**SECTION 87F REPORT OF LOGAN ARTHUR BROWN – WATER
QUALITY AND AQUATIC ECOLOGY**

**MANAWATŪ-WHANGANUI REGIONAL COUNCIL AND GREATER
WELLINGTON REGIONAL COUNCIL**

28 April 2023

Figure 2 Map showing the location of the proposed abstraction point (inferred from Volume III - Drawing Set – 07 Accommodation Works) and Tavistock Road flow recorder (proposed monitoring site) on the Koputaroa Stream. Taken from Ms Stout’s evidence.

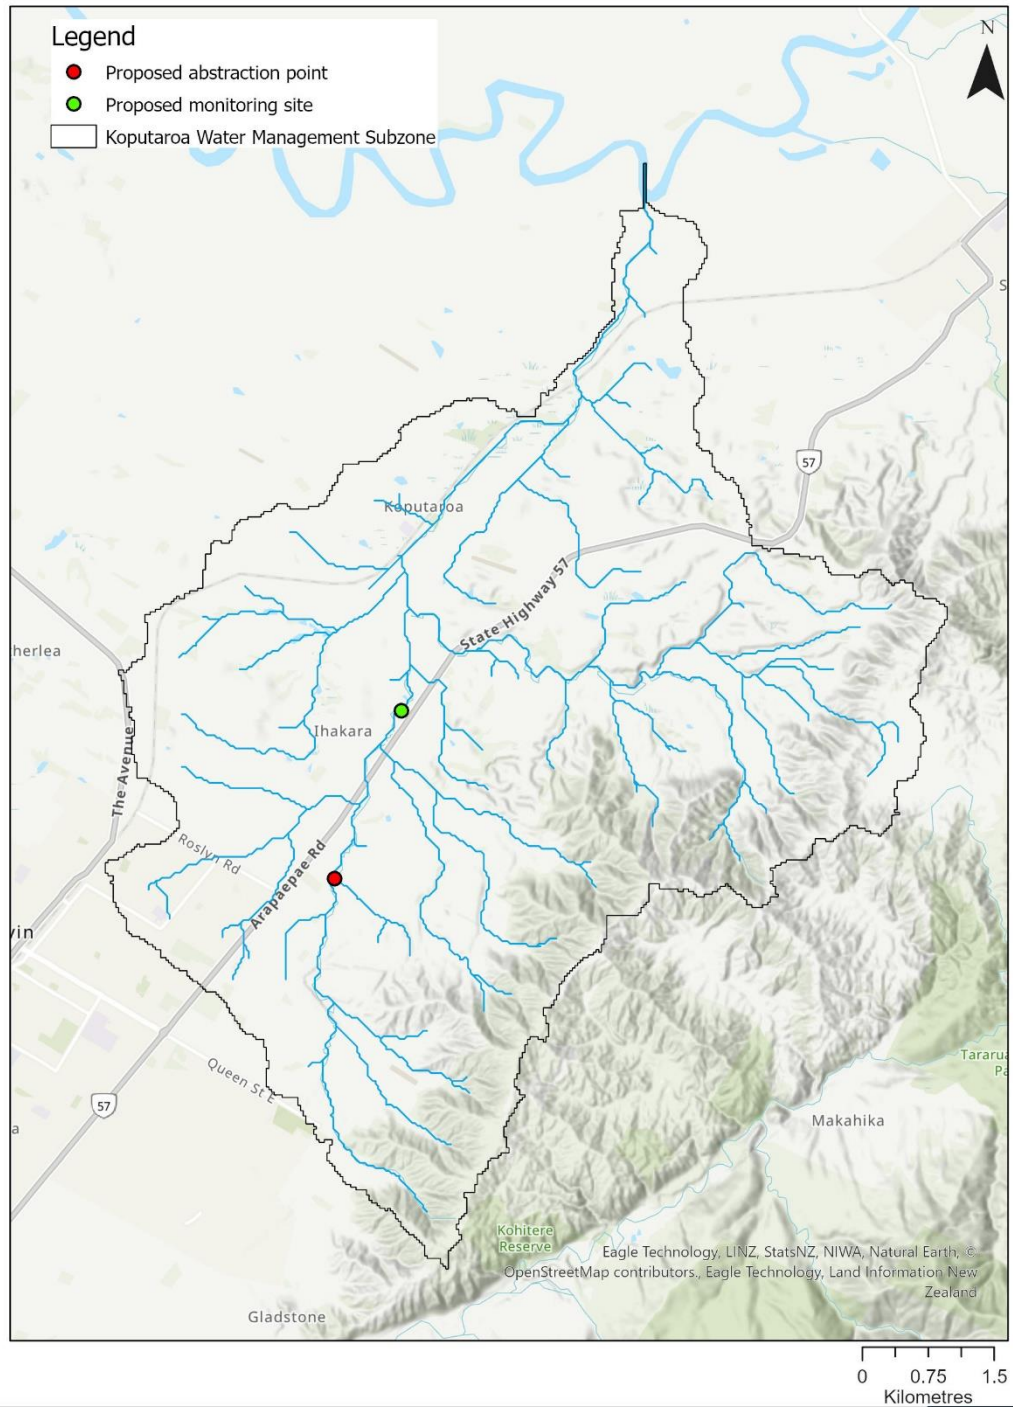
98. In order to manage instream effects, there must be a robust relationship between the proposed take location and the monitoring site used to inform the need to stop taking water. I note for the Koputaroa Stream that the proposed take location and flow recording location are a reasonable distance apart (refer to *Figure 1*, taken from Ms Stout's report). However, the Tavistock flow recording site is proposed to be the monitoring location to dictate the cessation of abstraction. There is limited information available to understand whether such a relationship exists between the take location and the Tavistock flow recording site. In my time at Horizons I have been involved in fish monitoring (night spotting),and undertaken fish barrier remediation when the upper sections of the Koputaroa Stream have ceased to have surface flow (pools were still present but no flow between them) however, I have never encountered this lack of flow at the Tavistock flow recording location.

- (a) Install a flow recording site at the proposed take location to which abstraction could be related to; or
 - (b) Undertake paired gaugings at the proposed take point and at the proposed monitoring location to establish a robust and accepted flow relationship. If this option were to be pursued it would need to be a matter contained with the proposed Ecological Management Plan. The additional requirement for this plan would be for Waka Kotahi to establish the flow relationship between the proposed abstraction point and the Tavistock Road flow monitoring location. This should involve the collection of at least 24 paired flow gaugings at flows below median flow as measured at the Koputaroa Stream Tavistock Road monitoring site, with at least 12 of these occurring at flows below half median flows as measured at the Koputaroa Stream Tavistock Road monitoring site.
